SUBJECT: REVIEW OF INTERNAL DRAFT TECHNICAL POSITION ON "REPOSITORY
DESIGN - THERMAL LOADS"

GEOSCIENCES & SYSTEMS PERFORMANCE BRANCH
DETAILED COMMENTS ON INTERNAL DRAFT TP
REPOSITORY DESIGN-THERMAL LOADS

Technical Position on Repository Design - Thermal Loads

Figure 1. Steps for Compliance Demonstration and Compliance Determination

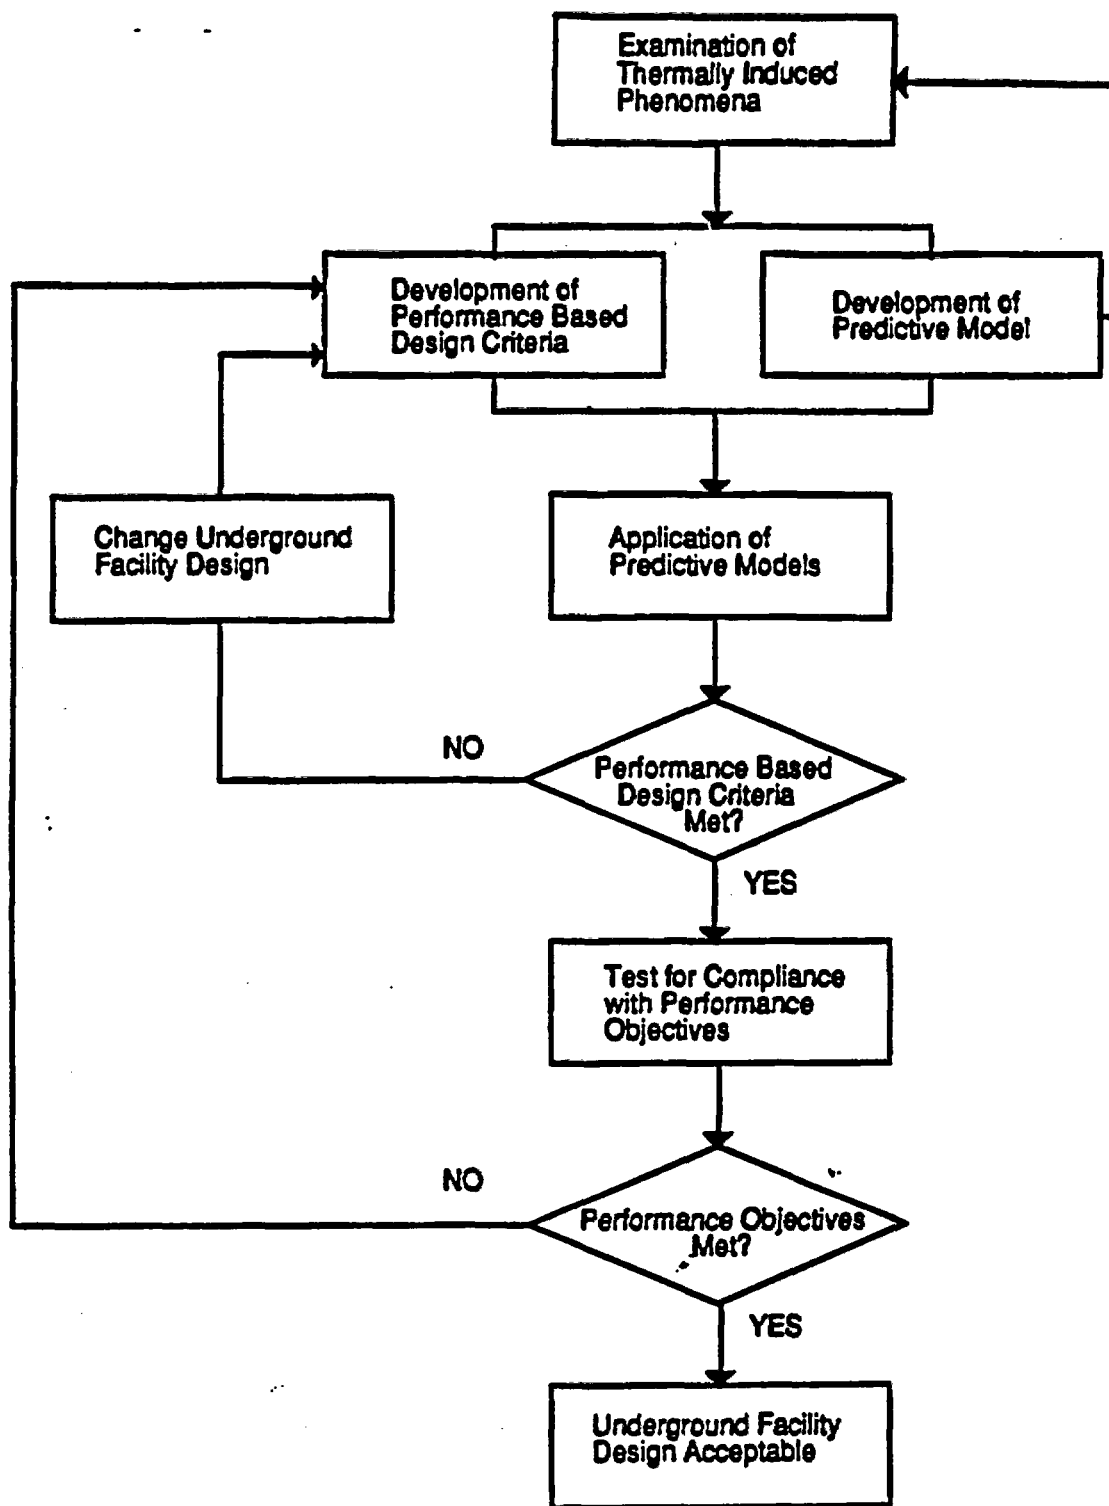
This sentence overstates the content of the TP. With one exception (the acceptability of an iterative analytical process based on a one-way coupled formulation in implementing prescribed predictive modeling), the TP provides no acceptance criteria for staff use in determining the acceptability of DOE's implementation of each step of the proposed methodology. The final paragraph of Section 1.0 (page 2) only indicates that the NRC requires data and information sufficient to allow staff to perform an independent analysis using "a methodology (such as that presented in this TP)." Needed data and information are not identified (the Standard Format and Content Guide is not expected to cover this level of detail) nor is any commitment to a particular methodology implied. There is no specific section of the TP explicitly outlining the "NRC compliance determination methodology." The only other reference to such is in the caption of Figure 1.

If the TP is to have utility as a compliance determination methodology for for NRC use in review of a license application, the TP will have to be expanded. Substantive, "acceptable" approaches for implementing all steps of the compliance demonstration methodology will be necessary (they should be included anyway, for guidance to DOE). The acceptance criteria for each step will be based on those "acceptable" approaches. The resultant product will then be suitable for direct incorporation into the standard review plan.

Figure 2. Iterative Process of Analyses

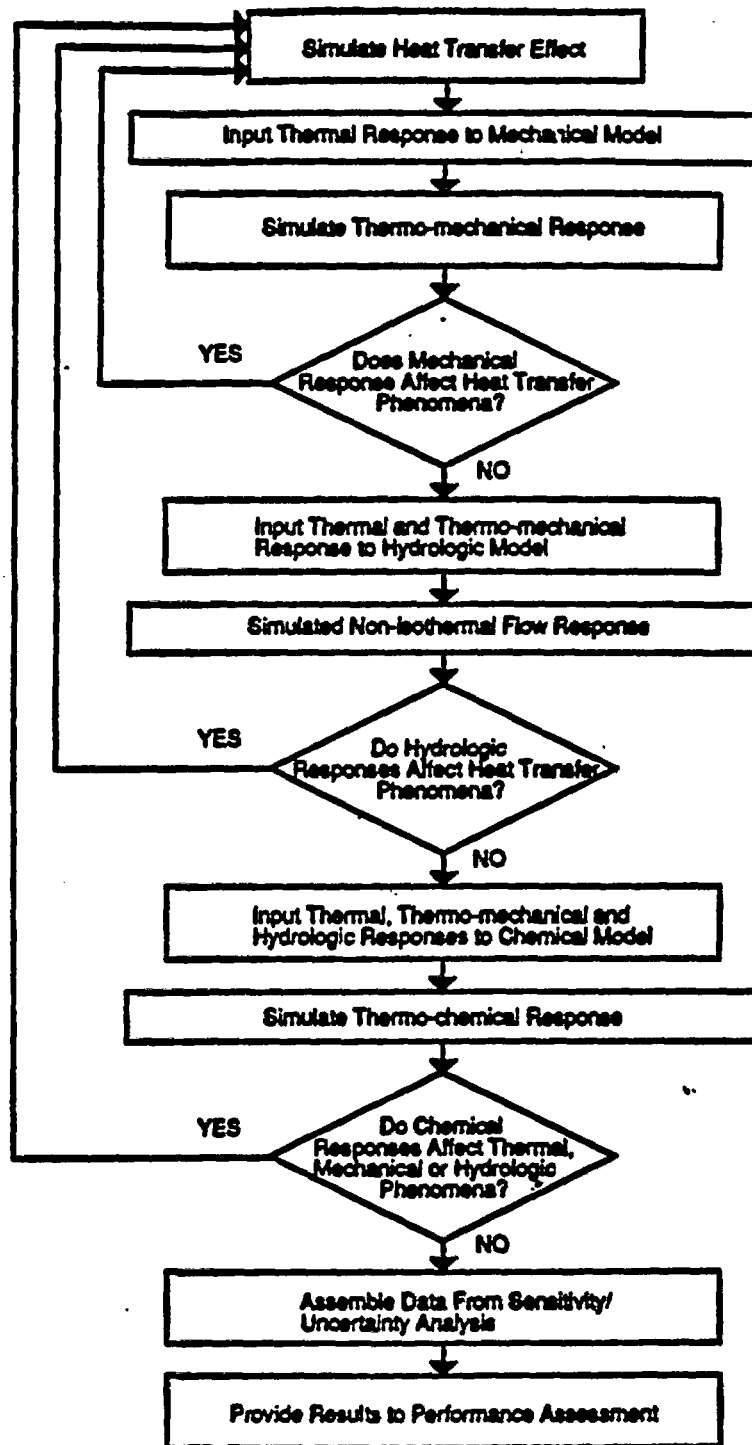
10. The flow chart in Figure 2 ends with "provide results to performance assessment." The step wherein there is a test for meeting the performance based design criteria is missing.
11. In taking the position that an "iterative analytical process based on the one-way coupled formulation of thermally induced phenomena" is acceptable "if interactive models are unavailable at the time of license application," the TP states in Section 4.1.3 (page 9) that the staff "recognizes that acquiring the knowledge necessary to develop such a model may require information which will be obtained during the performance confirmation program."
